SUNDRY NOTICES AND REPORTS ON WELLS
Do not use this form for proposals to drill or to re-enter an abandoned well. Use form 3160-3 (APD) for such proposals.

8. Well Name and No.
WHITE CITY 30 24 27 FEDERAL 1H

MOC has an signed change of operator for the subject well. MOC would like to make changes to the original APD. MOC would like to change well name to Commodore 30 W2PA Federal #1H. MOC would also like to change the pool to Sulphate Draw Wolfcamp (85780). The proration unit will change to 320 acres. The BHL will change to 330' FNL & 330' FEL, Sec 30 T24S R27E. Please see attached drilling program, drilling plan, corrected C102 & signed change of operator for details on these changes. Please call Bradley Bishop or Andy Taylor with any questions.

Mewbourne Oil Company, Commodore 30 W2PA Fed #1H

13 5/8" 10M BOPE & Closed Loop Equipment Schematic

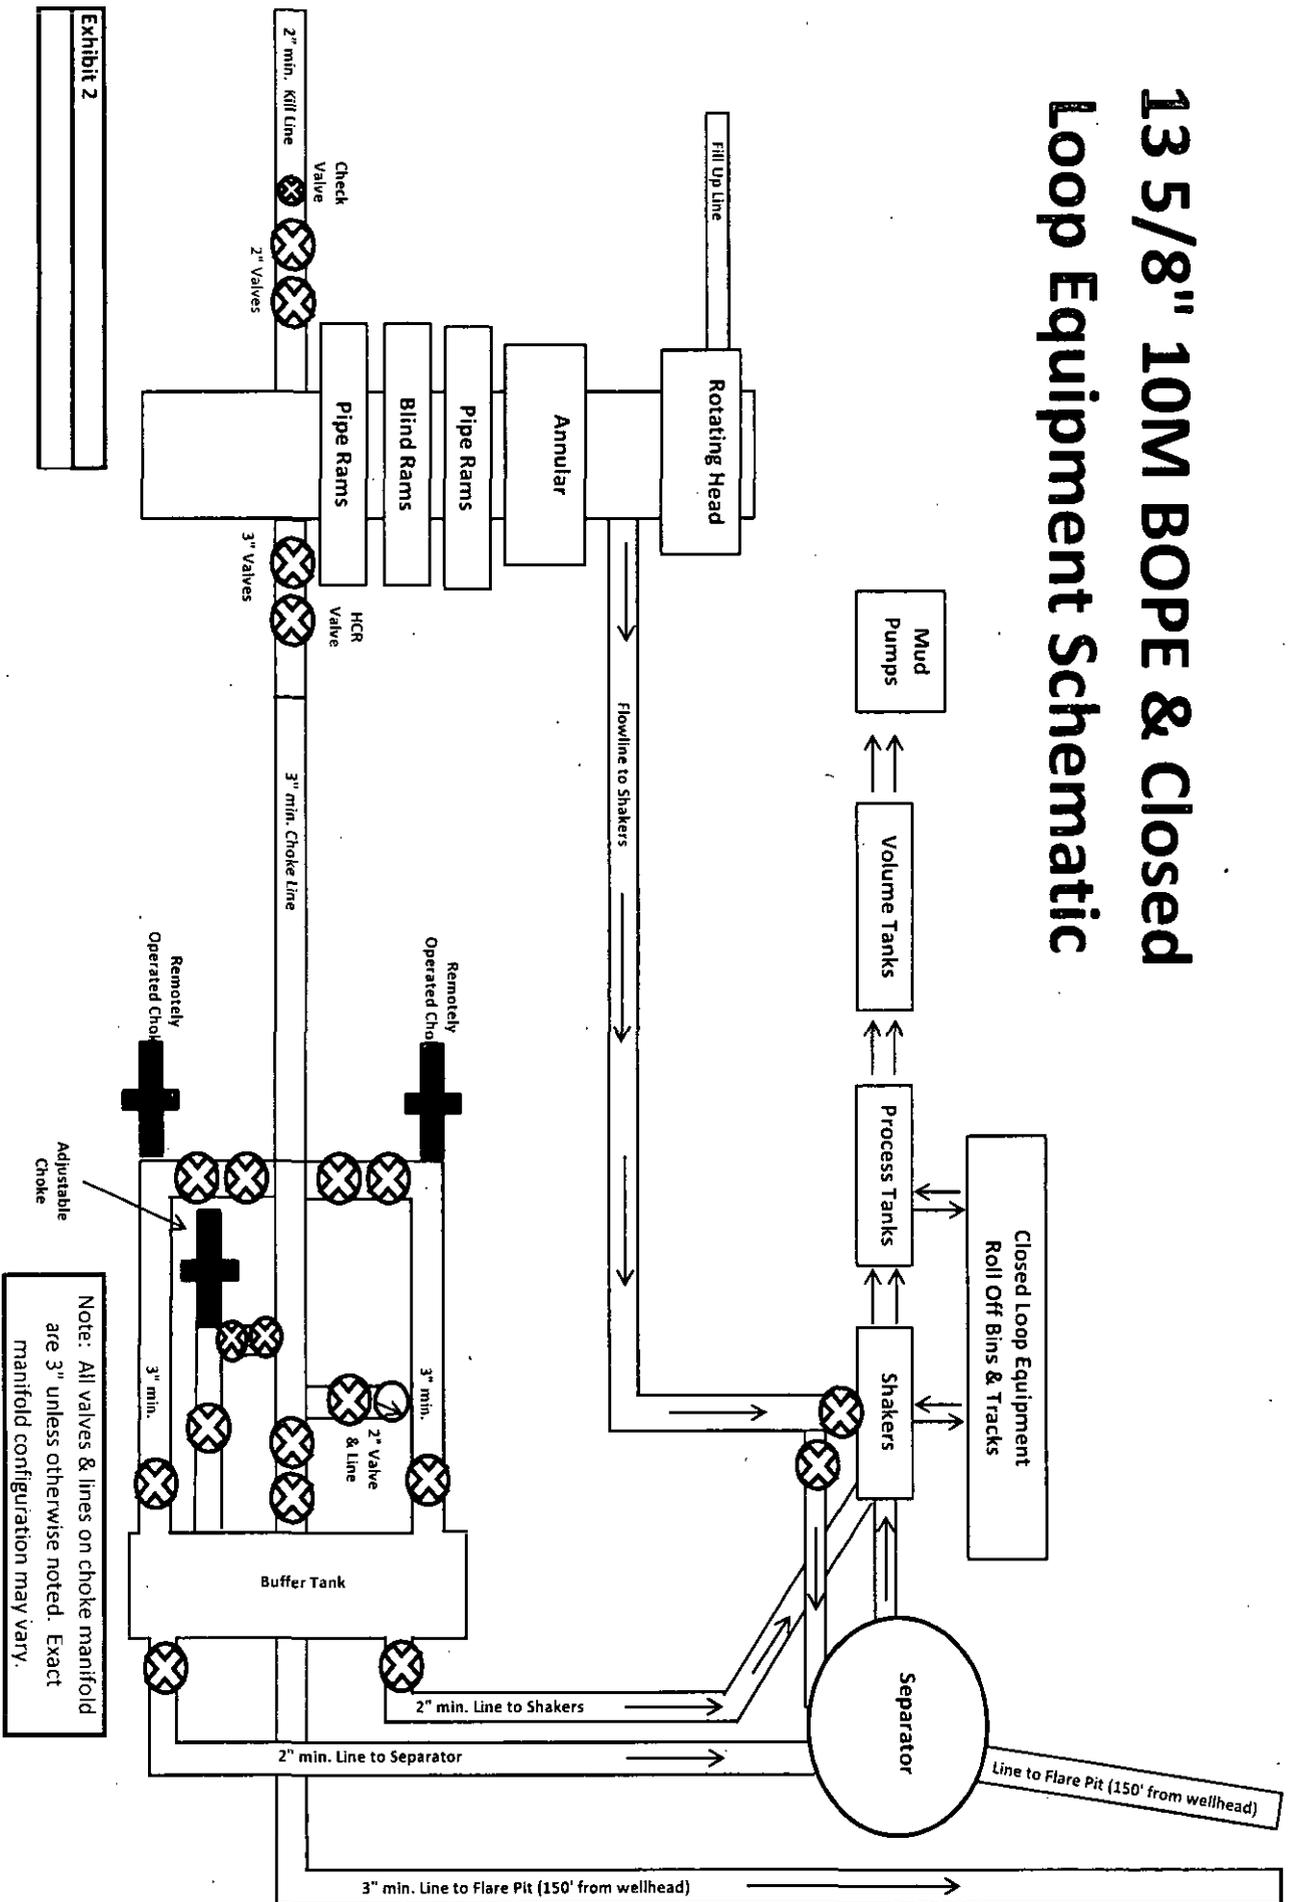
2. Variance approved to use flex line from BOP to choke manifold. Check condition of flexible line from BOP to choke manifold, replace if exterior is damaged or if line fails test. Line to be as straight as possible with no hard bends and is to be anchored according to *Manufacturer's requirements*. *The flexible hose can be exchanged with a hose of equal size and equal or greater pressure rating.* **Anchor requirements, specification sheet and hydrostatic pressure test certification matching the hose in service, to be onsite for review. These documents shall be posted in the company man's trailer and on the rig floor.** If the BLM inspector questions the straightness of the hose, a BLM engineer will be contacted and will review in the field or via picture supplied by inspector to determine if changes are required (operator shall expect delays if this occurs).

5. Minimum working pressure of the blowout preventer (BOP) and related equipment (BOPE) required for drilling below the 9-5/8 intermediate casing shoe shall be **10,000 (10M) psi**. **10M system requires an HCR valve, remote kill line and annular to match. The remote kill line is to be installed prior to testing the system and tested to stack pressure.**
